ADDENDUM No. 4

PROJECT NAME: Culebra Bulky Waste Collection Center (Project No. 55-000025)

DATE: December 10, 2013

PROJECT NO. 1301
PHASE CONSTRUCTION DOCUMENTS
DATE OCTOBER 19, 2013
DESCRIPTION TRAFFIC PLAN
C-4

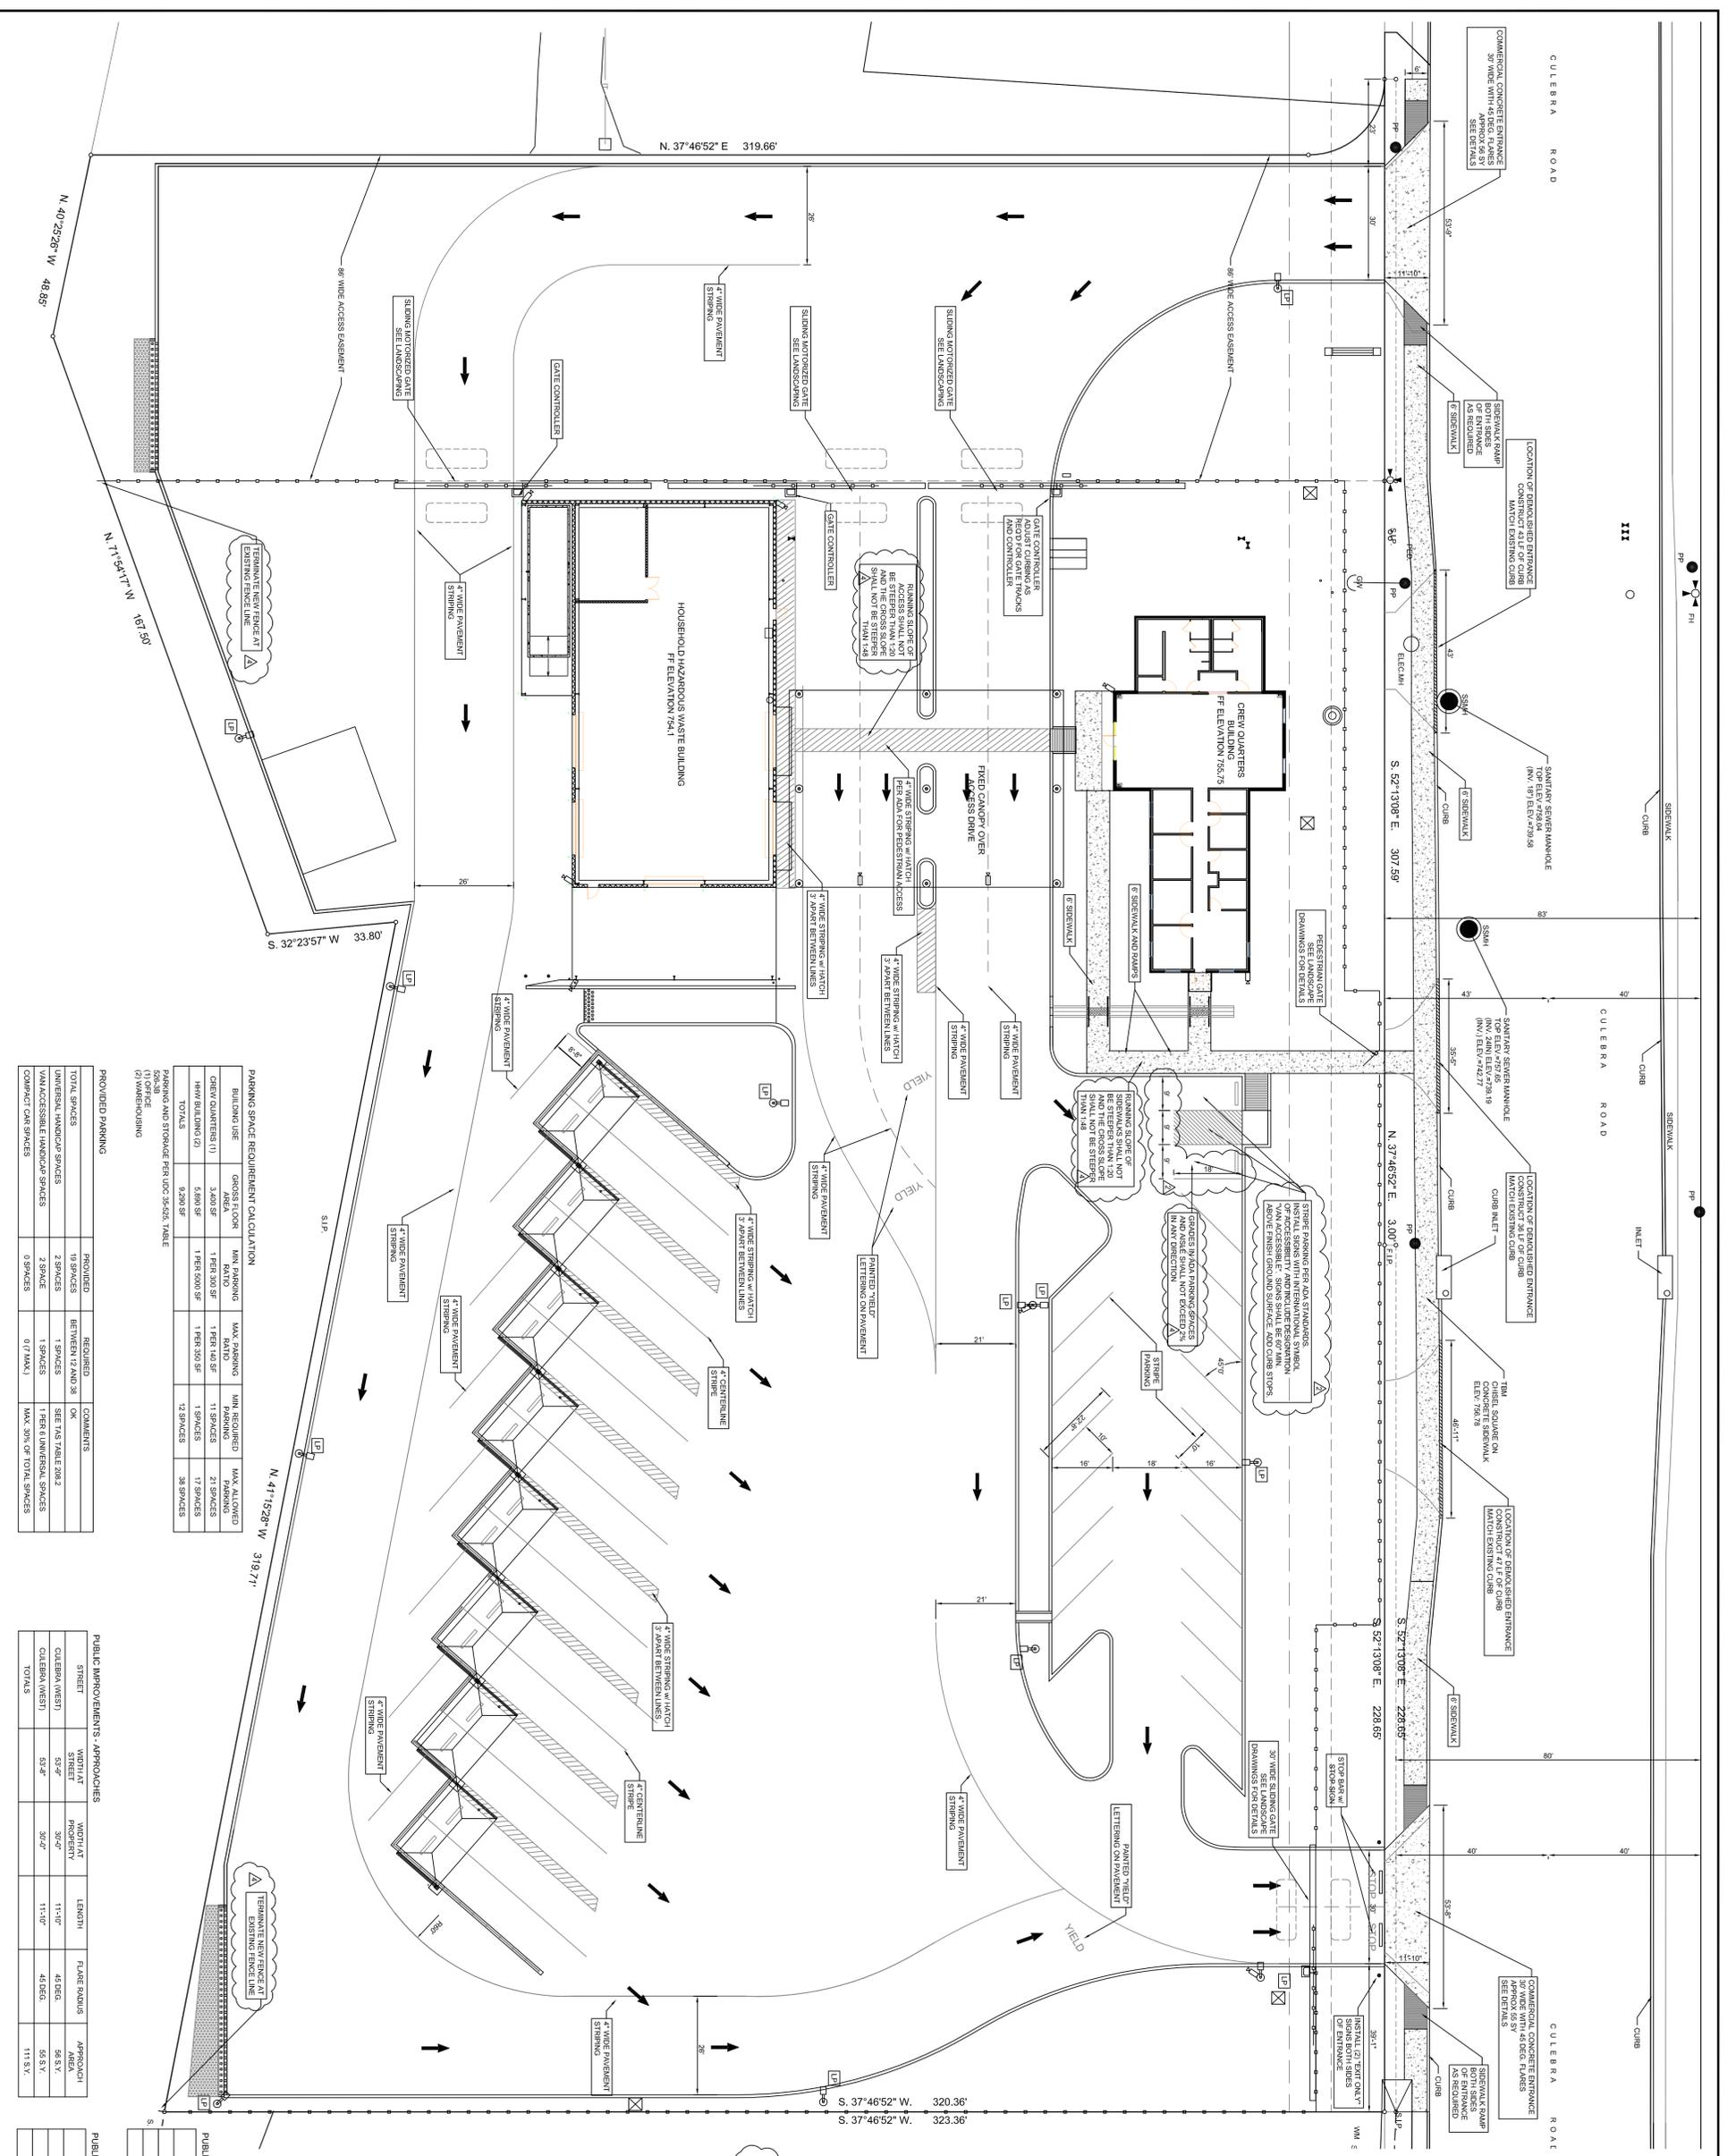
- C-4 Revised drawing dated 12/4/2013. Revisions include, but not limited to, added notes for grading requirements associated with access and parking, indicated termination locations of fence.
- C-8 Revised drawing dated 12/4/2013. Revisions include, but not limited to, revisions to communication handhole locations and site communication cabling.

TYP. GROUND SIGN DETAIL

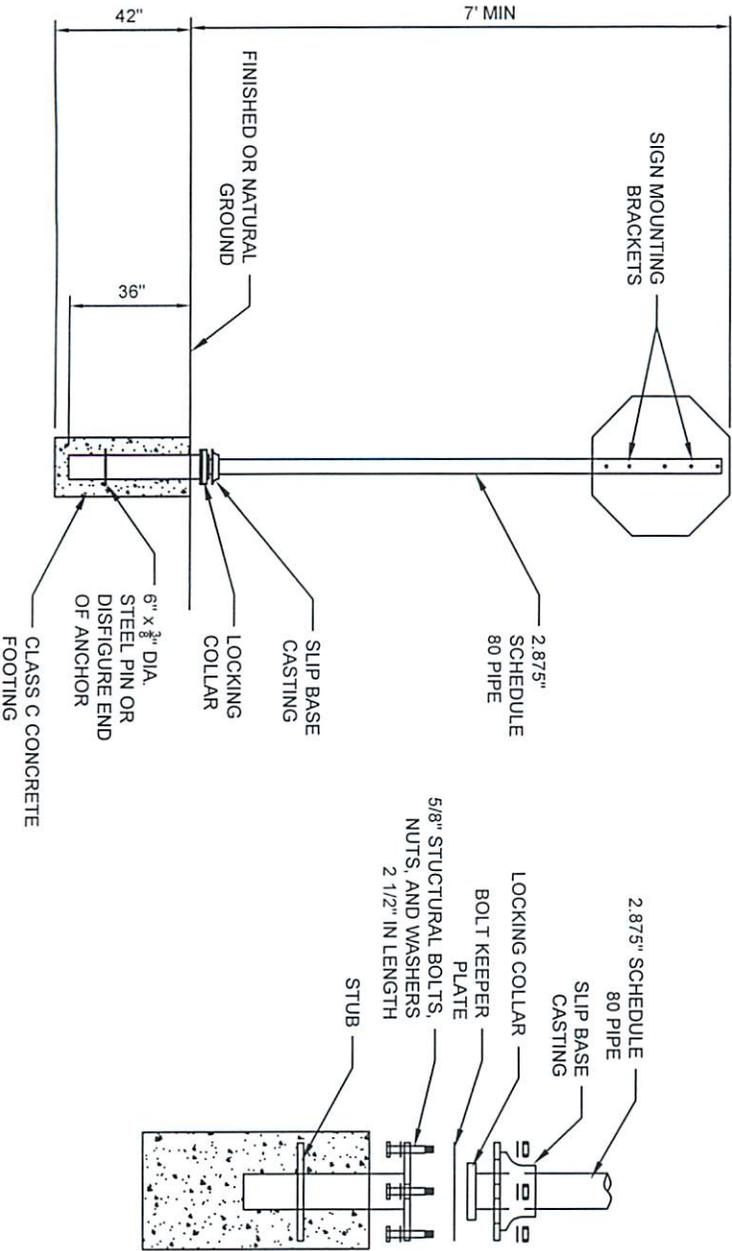
Answer: Signage for the project includes the project signs, traffic signs, and signage in the buildings. Please refer to details on the drawings, TxDOT/COSA standards for traffic signage, and Architectural specifications no. 10400. A typical ground sign detail has been included.

1 TECHNOLOGY NETWORKING CONNECTIVITY SITE PLAN

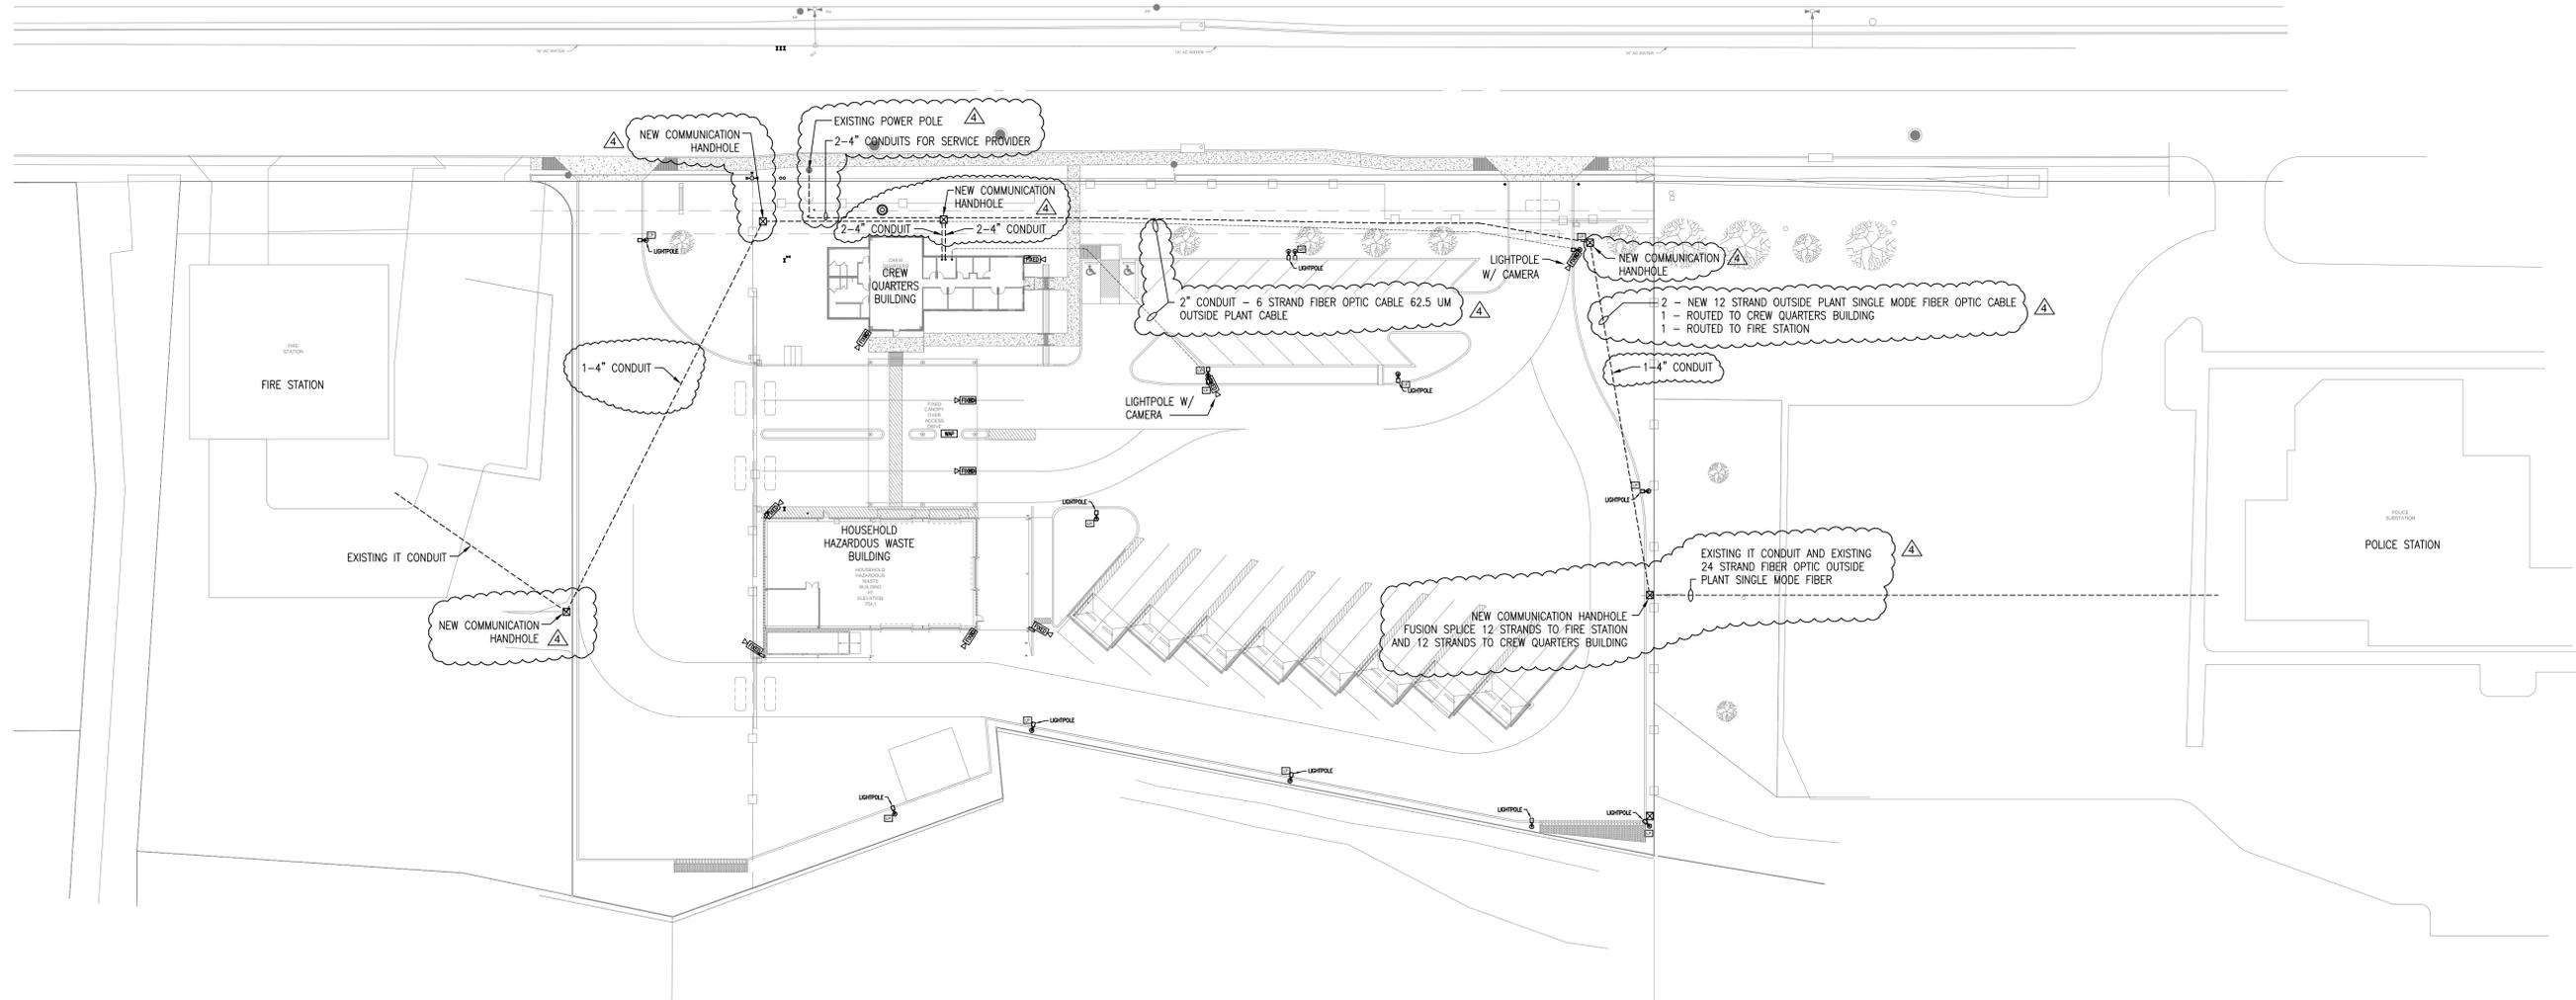
- 6. Sheet C-8 shows an existing communications handhole on the west side of the property and new cabling handholes. The notes on sheet C-8 reference the IT drawings for more information. There is nothing on the old or new IT drawings about this. What size and quantity of conduit will be required? What size are the handholes?**

Answer: A typical communication handhole detail has been added to sheet T-7. The dimensions of the handhole are shown on the drawing. Handholes shall be Hubbell Power System (Part No.

PG2436BA24), or approved equal. The location and number of the handholes, and routing of the conduit cabling has been revised. Please see revised sheets C-8 and T-1 to determine the type, size, and quantity of conduit/cabling required.
